SUBJECT: Addendum 1

G.W. Carver Freshman Facility
Kitchen and Toilet Renovations
For
Coffee County Schools

ADDENDUM NO. 1
April 9, 2021

1 ELECTRICAL COMPOSITE PLAN
E1001 SCALE: 1"=30'-0"

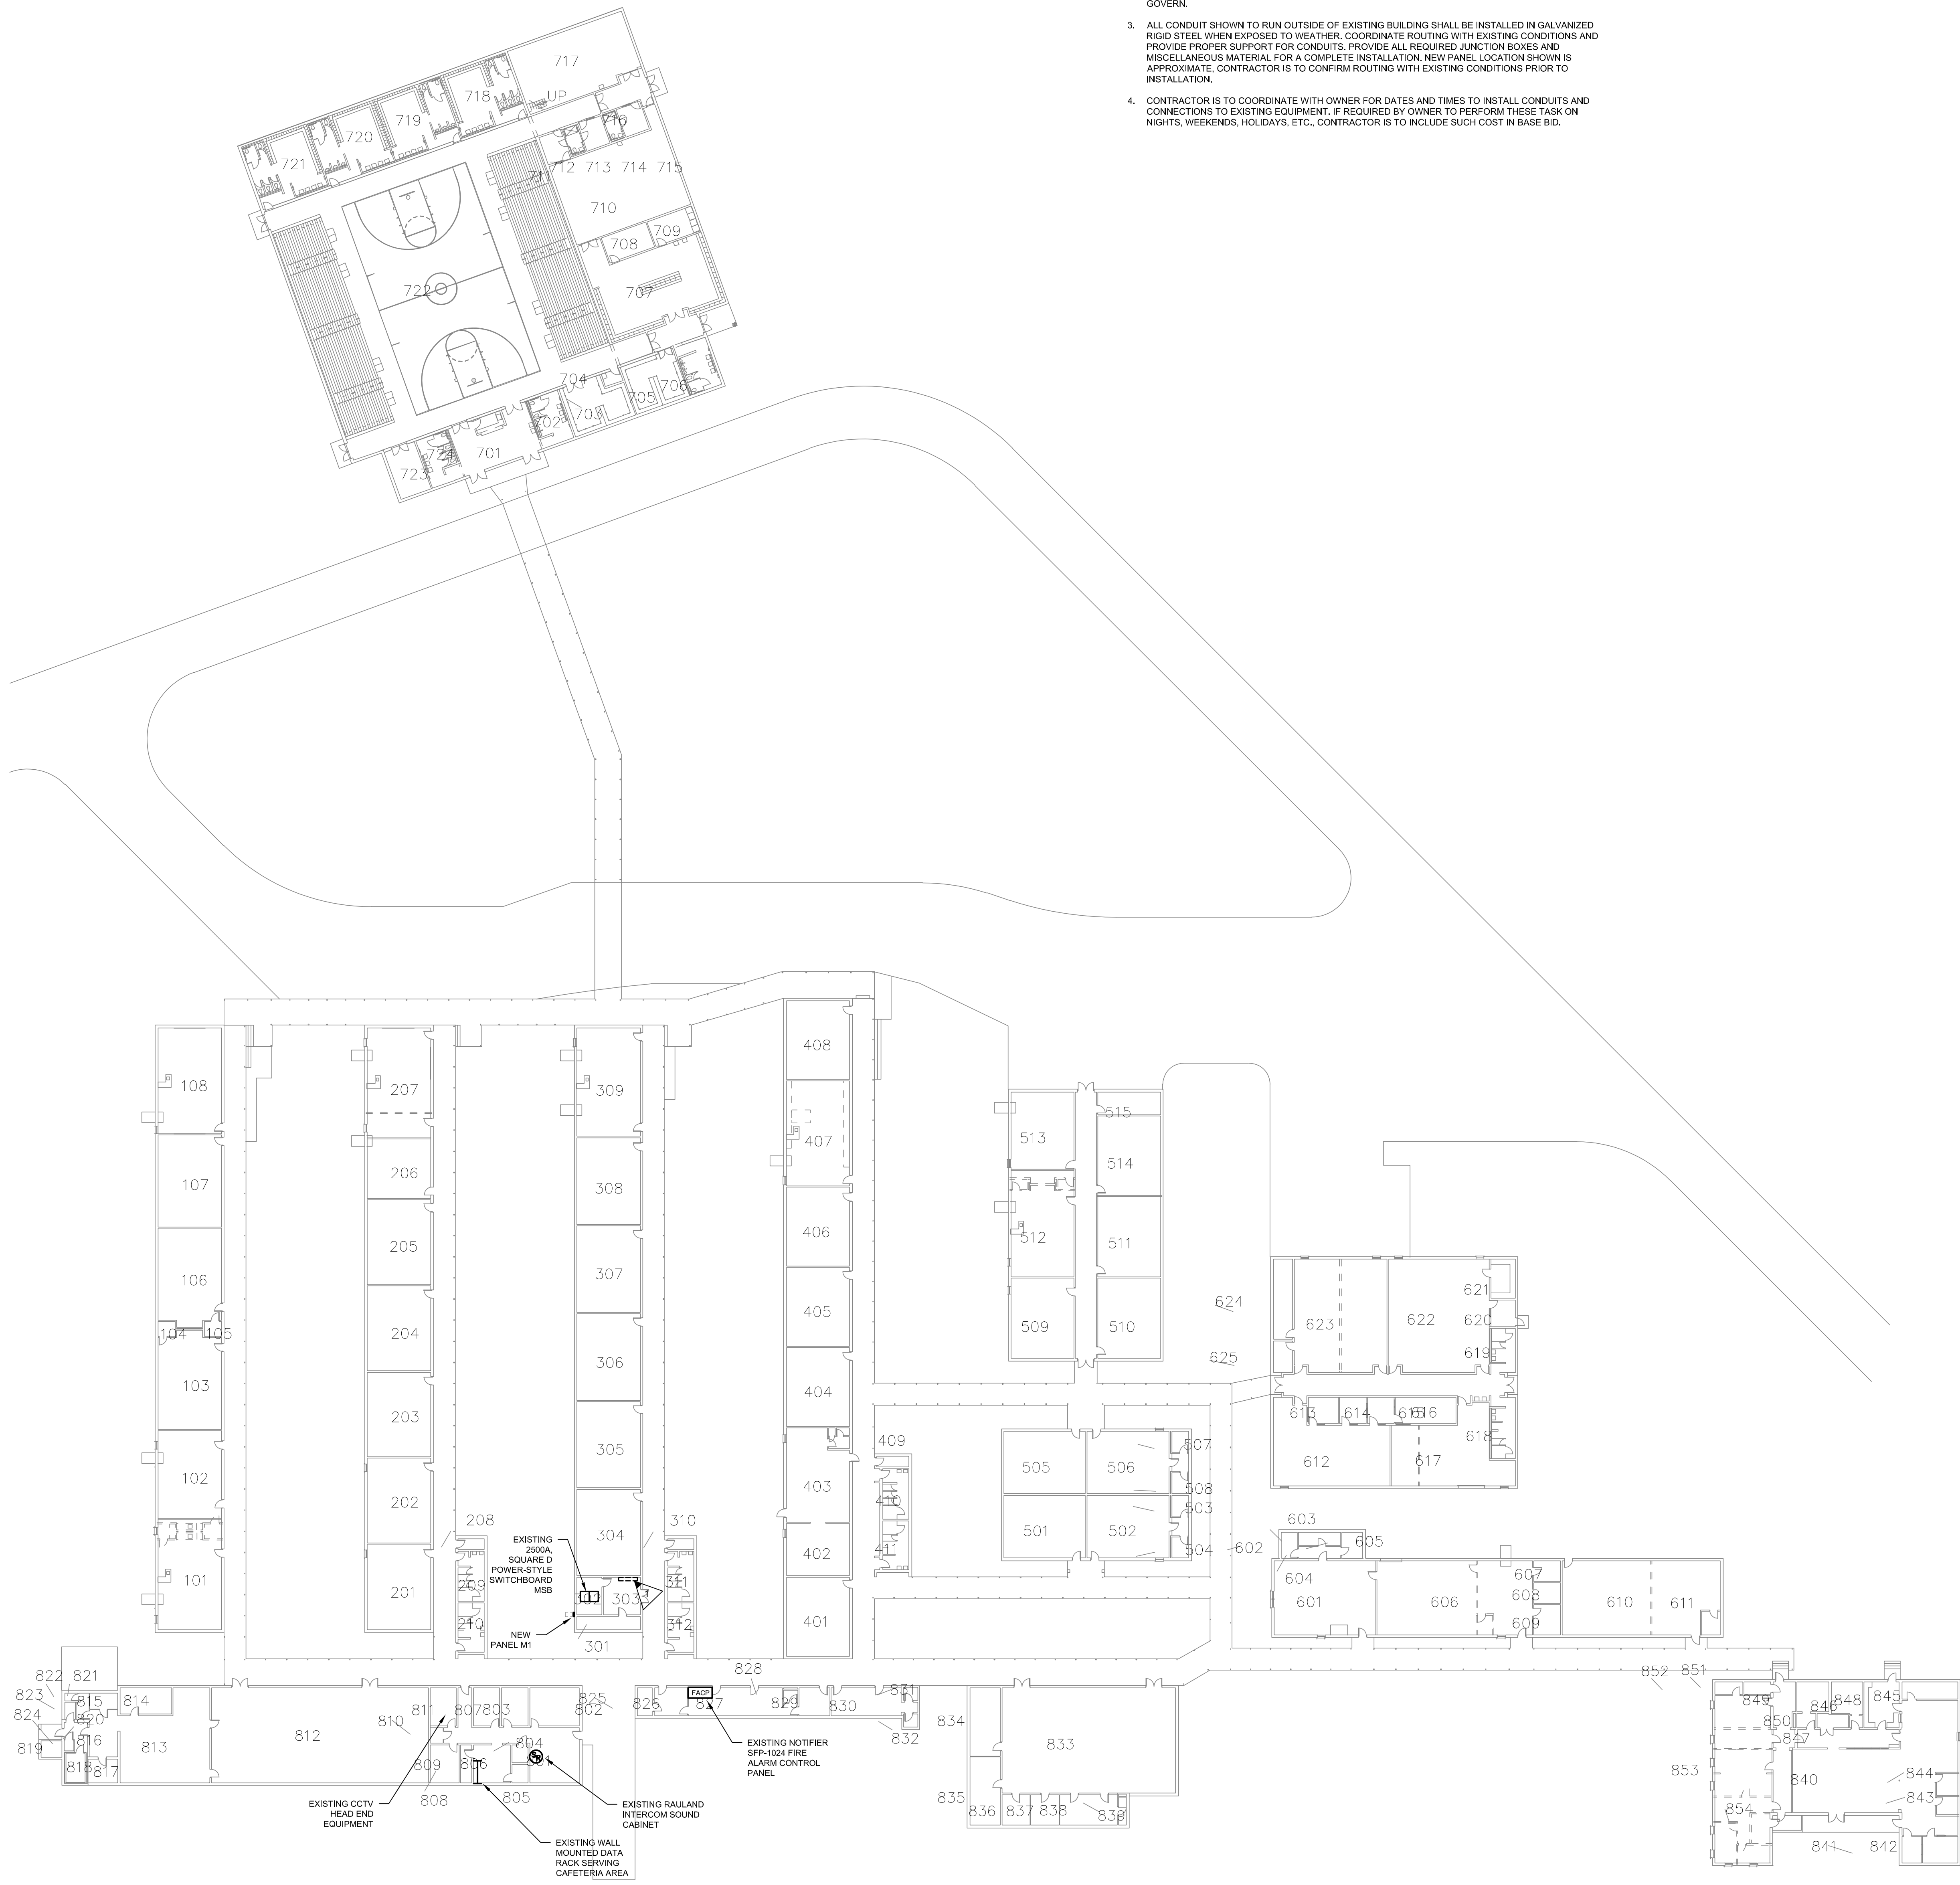
- 16. Sheet E1001, Electrical Composite Plan
 - 1. Delete in its entirety and replace with the attached Drawing Sheet E1001. Summary of changes are as follows: Low voltage systems head end equipment (fire alarm control panel, intercom sound cabinet, wall mounted data rack, and CCTV head end) locations were added.
